Comments:

1. D000183 Rev C, S/N B5172, labelled "B5", used for 40m SRM
2. Deviations from schematic marked in **RED**
3. Only one channel was checked, I assume that all 4 channels are identical

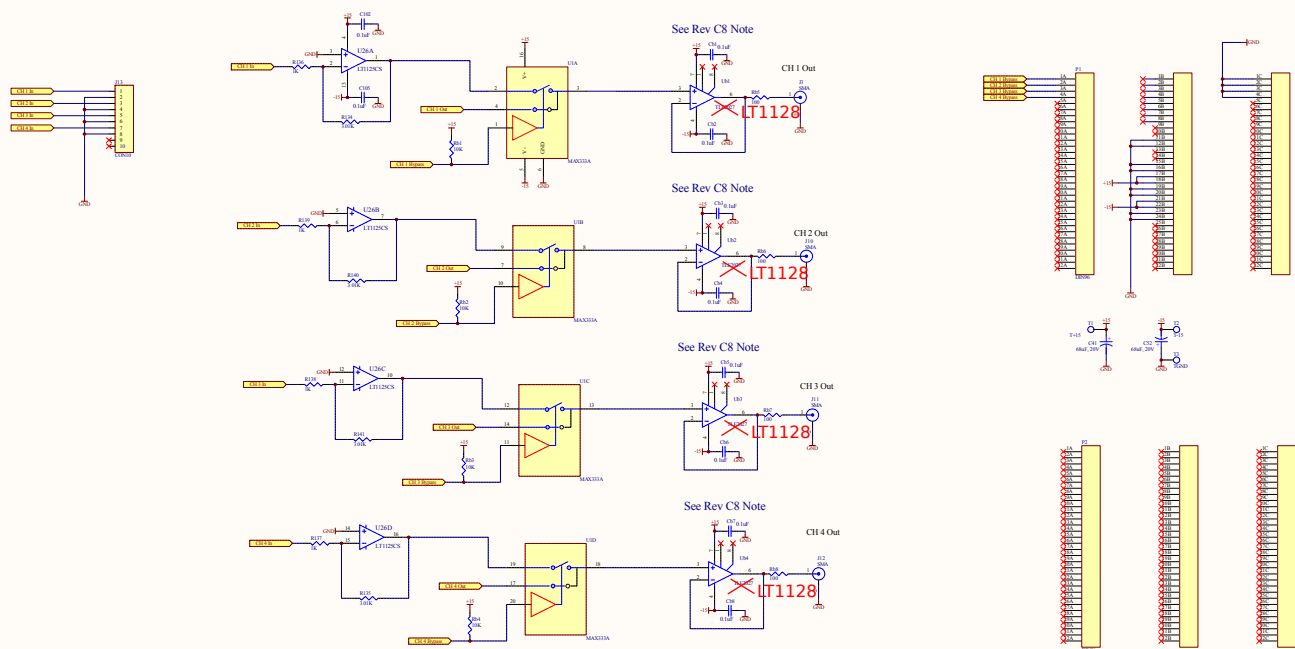
Proposed changes:

1. Get rid of DC gain of 3 (change R134, R140, R141, R135 from 3.01k to 1k, and R149, R114, R48, R5 from 4.53k to 1.5k)
2. Change critical resistors from thick-film to thin film
